## RB204-06/07

### R602.10.5

**Proponent:** Edward L. Keith, APA-The Engineered Wood Association

**FIGURE R602.10.5(2)**  
**WALLS WITH 6:1 ASPECT RATIO USED WITH CONTINUOUS WOOD STRUCTURAL PANEL SHEATHING**

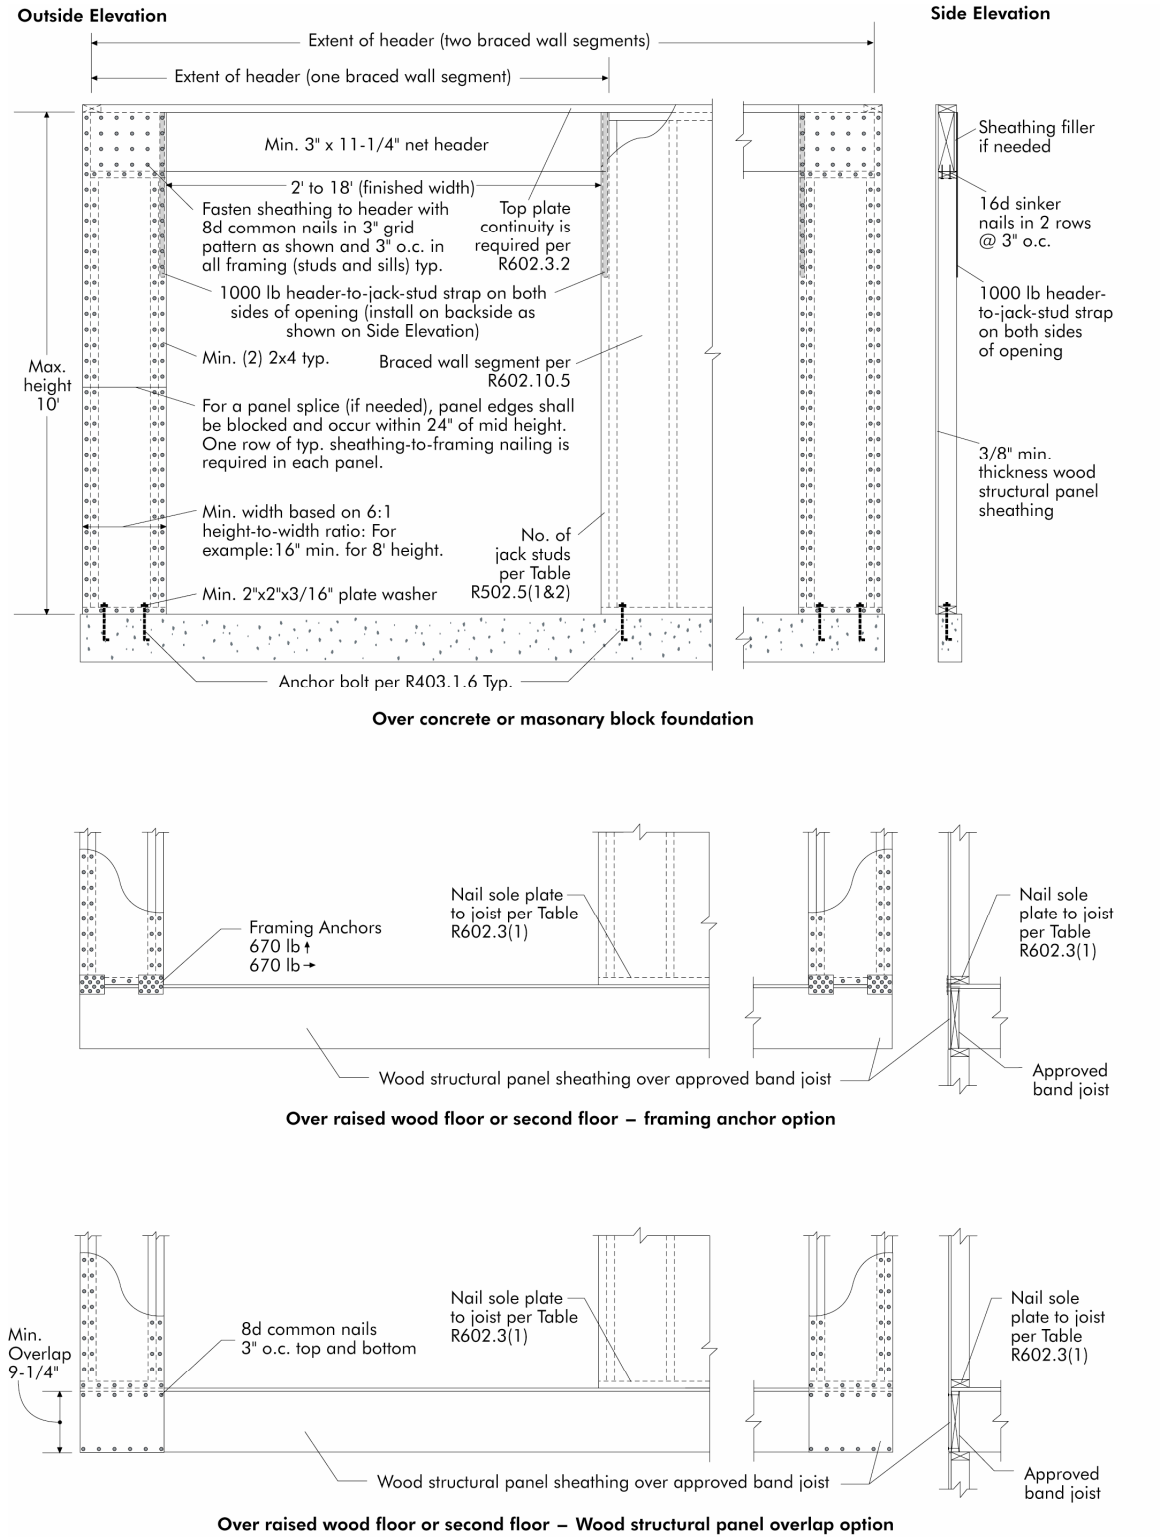
- c. Walls segments having a maximum 6:1 height to width ratio ~~on either or both sides of openings in garages attached to fully sheathed dwellings shall be permitted to be built in accordance with Section R602.10.6.2 and Figure R602.10.6.2 R602.10.5(2) except that a single bottom plate shall be permitted and two anchor bolts shall be placed at 1/3 points. In addition, tie down devices shall not be required and the vertical wall segment shall have a~~ The maximum 6:1 height-to-width ratio is based on (with height being measured from top of header to the bottom of the sill wall segment bottom-plate). This option shall be permitted for the first story of two-story applications in Seismic Design Categories A through C. For purposes of calculating the percentage of panel bracing required by Table R602.10.1, the width of the full-height sheathing segment shall be equal to its measured width.

**Reason:** The purpose of this proposal is to add to the content of the code by permitting a narrow segment bracing option to give more flexibility for builders to meet wall-bracing requirements.

Footnote c currently permits an aspect ratio of 6:1 if a modified version of the portal frame (Section R602.10.6.2) is used in conjunction with wood structural panel continuously sheathed walls. This proposal adds a figure describing the 6:1 aspect ratio wall segment. Previously, the footnote referenced another figure and then enumerated exceptions to that figure, making it difficult to use the provisions.

**Figure 1.** Load-displacement backbone curves of proposed 6:1 bracing compared to existing permitted 4:1 and 2:1 bracing segments. All segments shown were tested with no hold downs, no end restraint and plate washers finger tight plus ¼ turn.

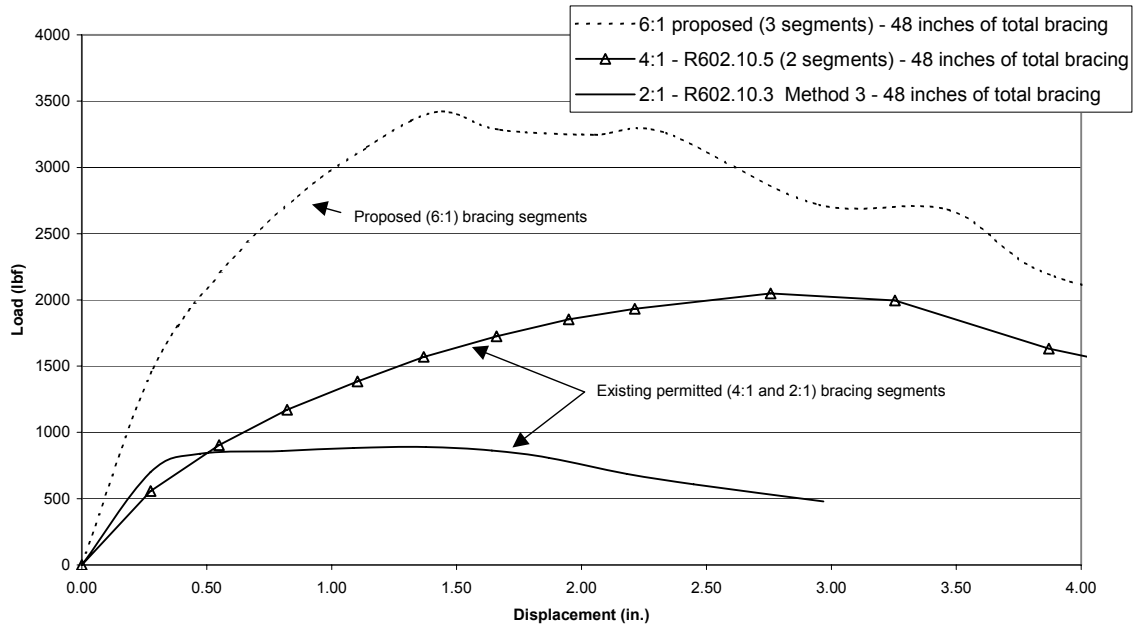
- 1) When equal amounts of bracing are compared, the proposed performs significantly better than currently permitted bracing, as shown in Figure 1. The proposed requires three 16-inch wide segments to equal the same bracing amount as one single 48-inch wide segment or two single 24-inch wide segments.

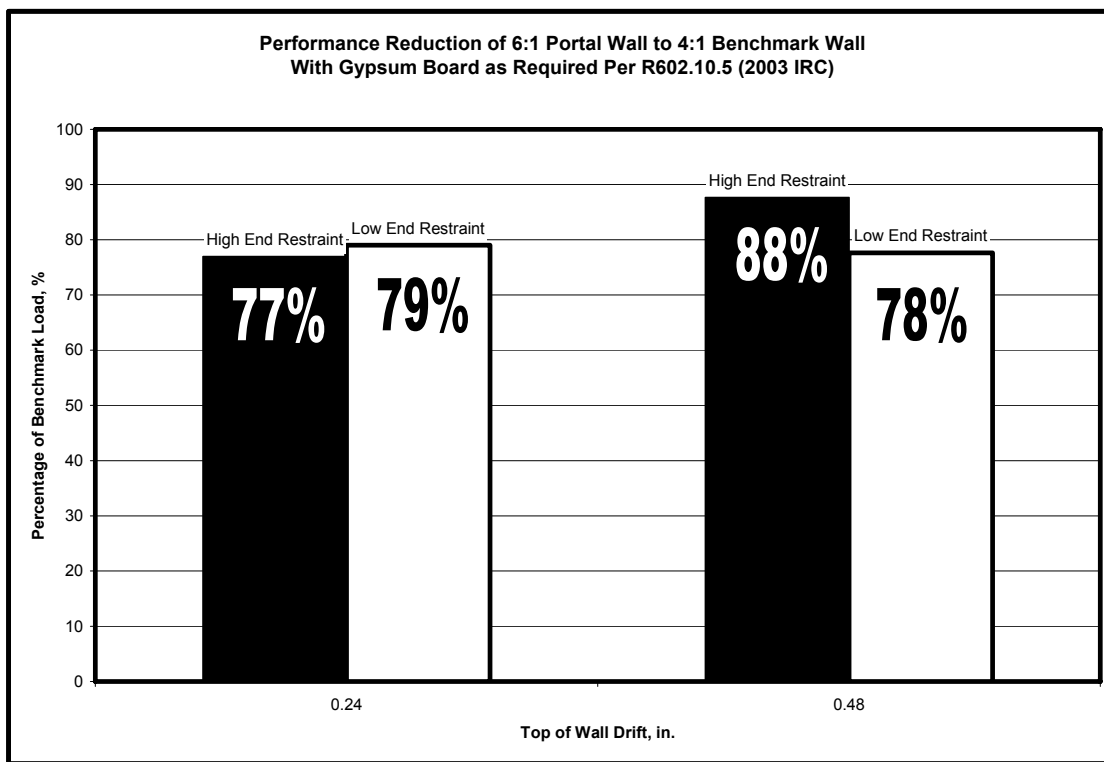
Figure 1 summarizes the results of this testing. As indicated in the figure, the performance of the 6:1 portal frame with gypsum falls below the 4:1 baseline wall with gypsum. Aside from the addition of gypsum on the interior, the walls tested by Simpson match the installation details of the walls tested by APA in T2003-48.

**Reason:** Strengthen code by adding new requirements. This code change modifies the 6:1 narrow wall allowed on either side of garages by adding one 3000 pound tie-down device (holdown) on each side of the opening.

**FIGURE 2**

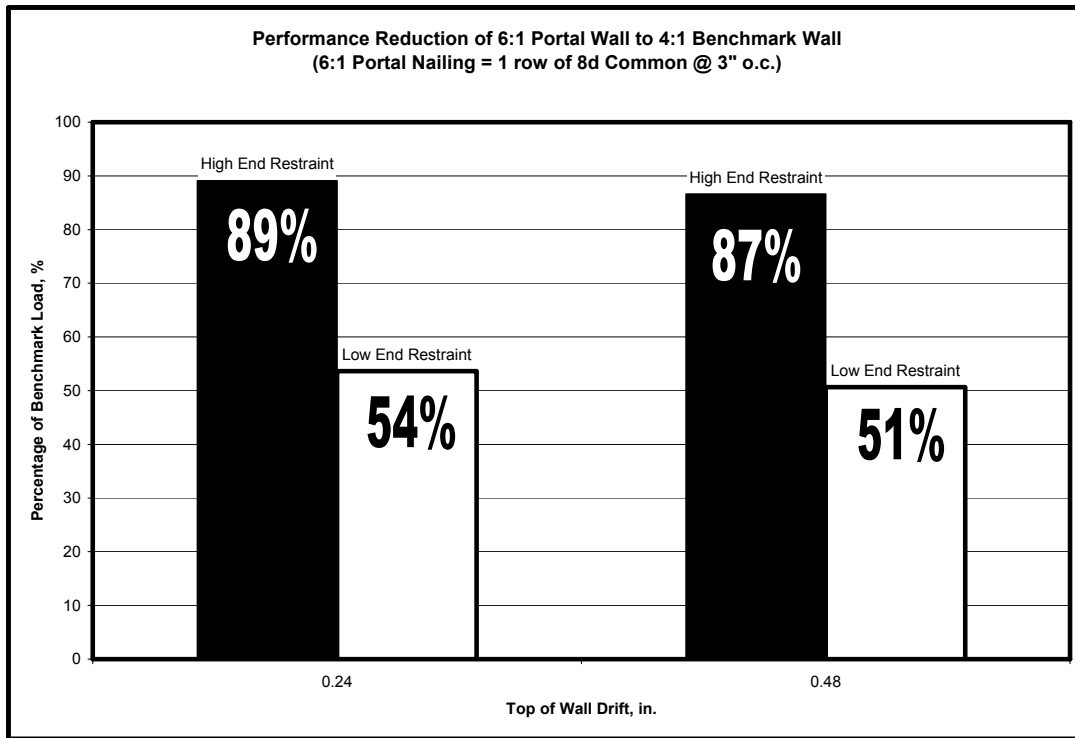
Subsequent to its approval in 2004, APA test report T2004-54 was submitted to show that the 6:1 portal frame was “relatively tolerable” to common installation errors. In this test program, only portals with a high degree of end restraint were evaluated. This restraint was achieved using a Simpson Strong-Tie holdown with an ultimate load of over 15,000 pounds. This is significantly more than could ever be expected to be provided by a single return wall. Because no testing was available for common installation errors on 6:1 portal frames with a low degree of end restraint, Simpson Strong-Tie tested these applications. The performance information is summarized in Figures 2 and 3. As indicated, a high degree of end restraint is required to overcome load reductions due to common installation errors.

**FIGURE 3**

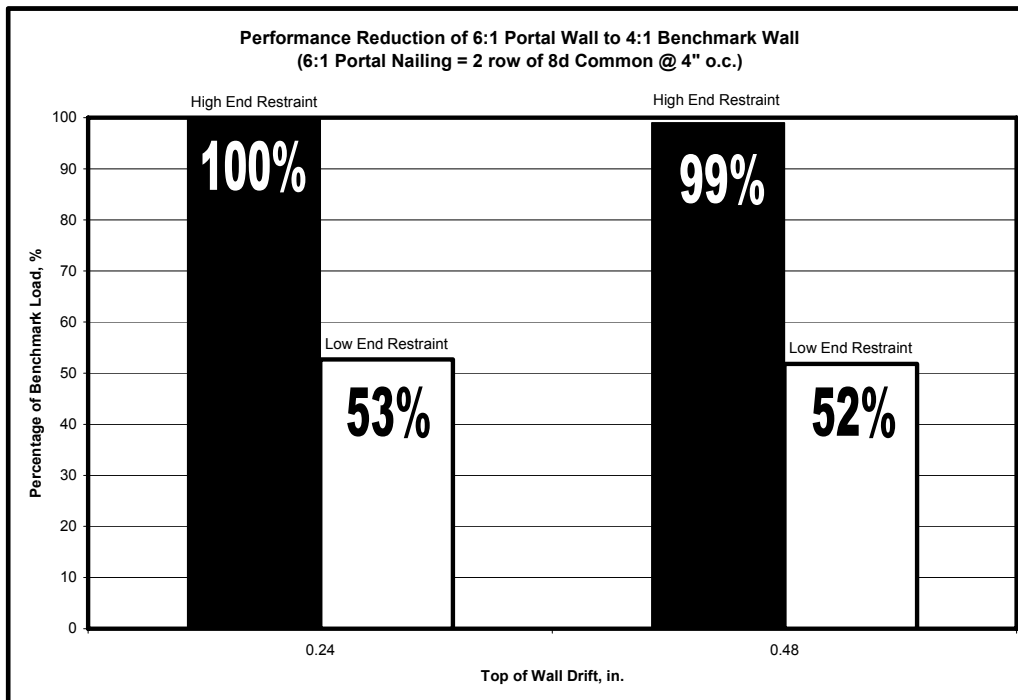
These graphs show that simply having the nail spacing off by one inch results in a reduction in capacity of almost one half at realistic deflection levels. The addition of a tie-down significantly improves the performance of walls that are not built perfectly.

**FIGURE R602.10.5**  
**TYPICAL EXTERIOR CORNER FRAMING FOR CONTINUOUS STRUCTURAL PANEL SHEATHING;**  
**SHOWING REQUIRED STUD-TO-STUD NAILING**

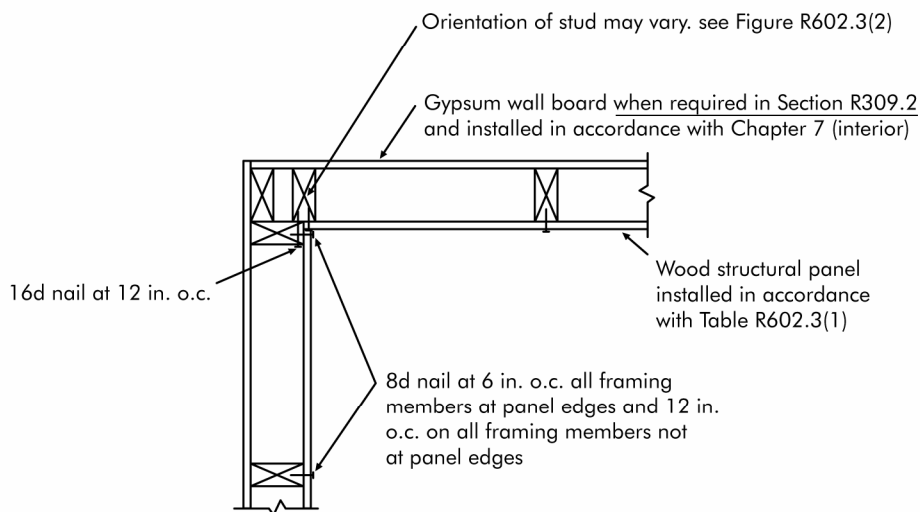
**Reason:** To clarify the intent of the code.

Section R309.2 of the IRC dictates where gypsum board is required in a structure built in accordance with the IRC. The callout in Figure R602.10, the way it is currently written, has been misconstrued to indicate that gypsum wall board **MUST** be used in conjunction with the corner detail. This is not the case. The proposal made and approved in the 04-05 cycle (RB-166-04/05) modified the name of this figure to indicate that the stud-to-stud nailing requirement was the "purpose" of the figure. This proposal is being made to further clarify the intent of the figure and eliminate the possibility of conflicting requirements in the Code.

**FIGURE R602.10.5**

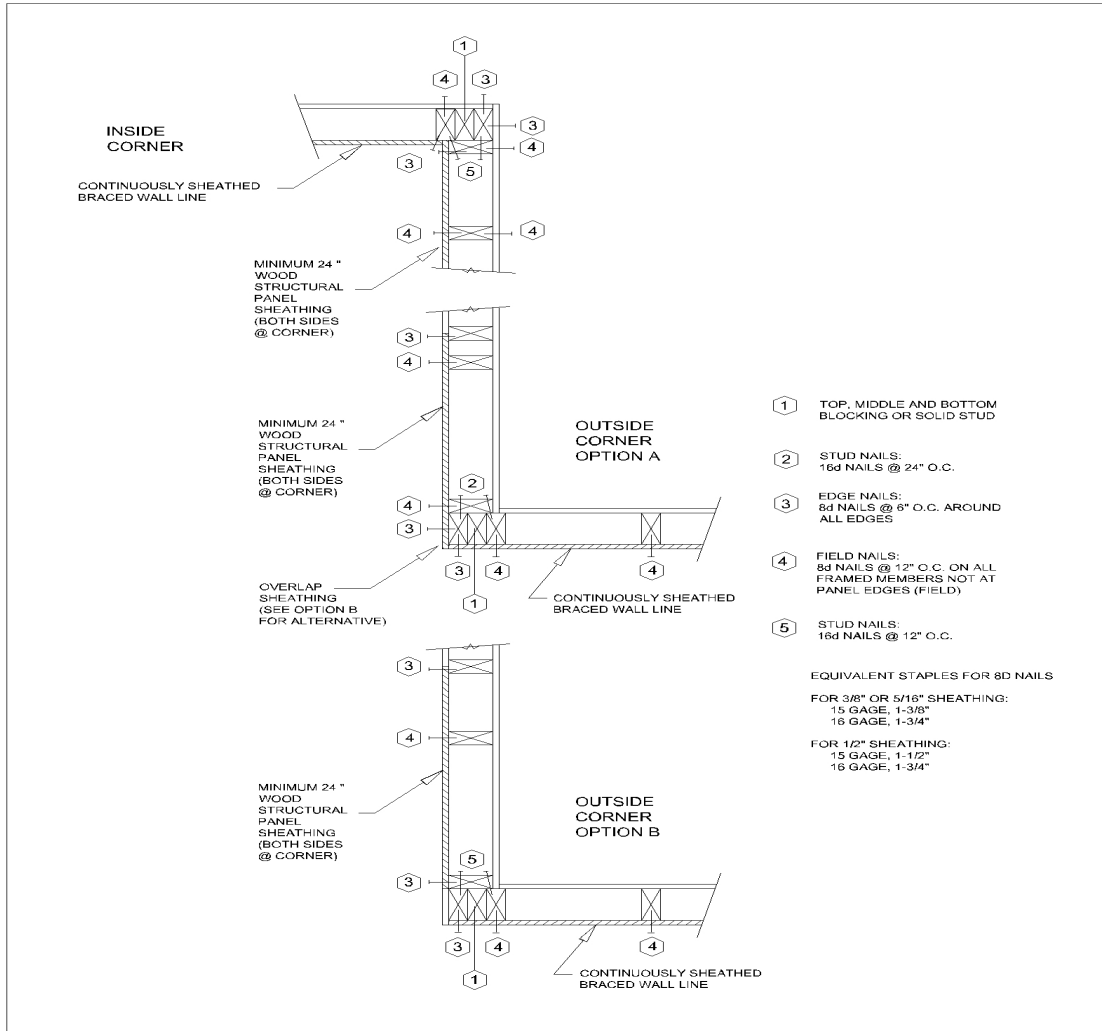
**Reason:** Based on the ad-hoc Reno meeting, it was determined that 24" sidewalls were required when using the continuous structural panel sheathing, and this figure reflects that requirement. The figure also provides an optional framing method for the exterior corner, which allows the framer to walk-up the exterior wall.

The Reno ad-hoc delegates agreed that continuous structural panel sheathing could be applied to a single braced wall line instead of the whole house. They also agreed that when using continuous structural panel sheathing along a single braced wall, the adjacent side walls have to be sheathed a minimum of 24" around the corner to transmit the forces around the corner. If continuous structural panel sheathing can be applied to a single braced wall line, the corner detail has to be corrected to reflect this change.

The optional exterior wall detail provides an equivalent framing method which will allow the framers to walk-up the adjacent side walls. Currently, Figure 602.10.5 is sufficiently difficult and dangerous to construct, - the adjacent wall has to be slid in place around the continuous structural panel sheathed wall.

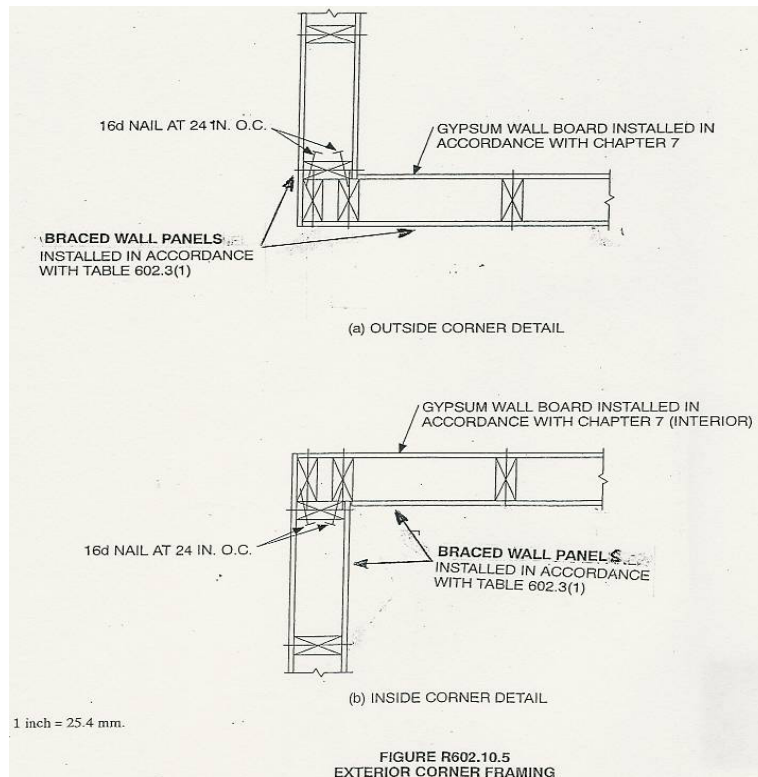
A coordinated change to Figure R602.10.5 is submitted to broaden the use of the figure for fiberboard structural panel sheathing and wood structural panel sheathing braced wall panel construction method.

### 2. Delete Figure R602.10.5 and substitute as follows:
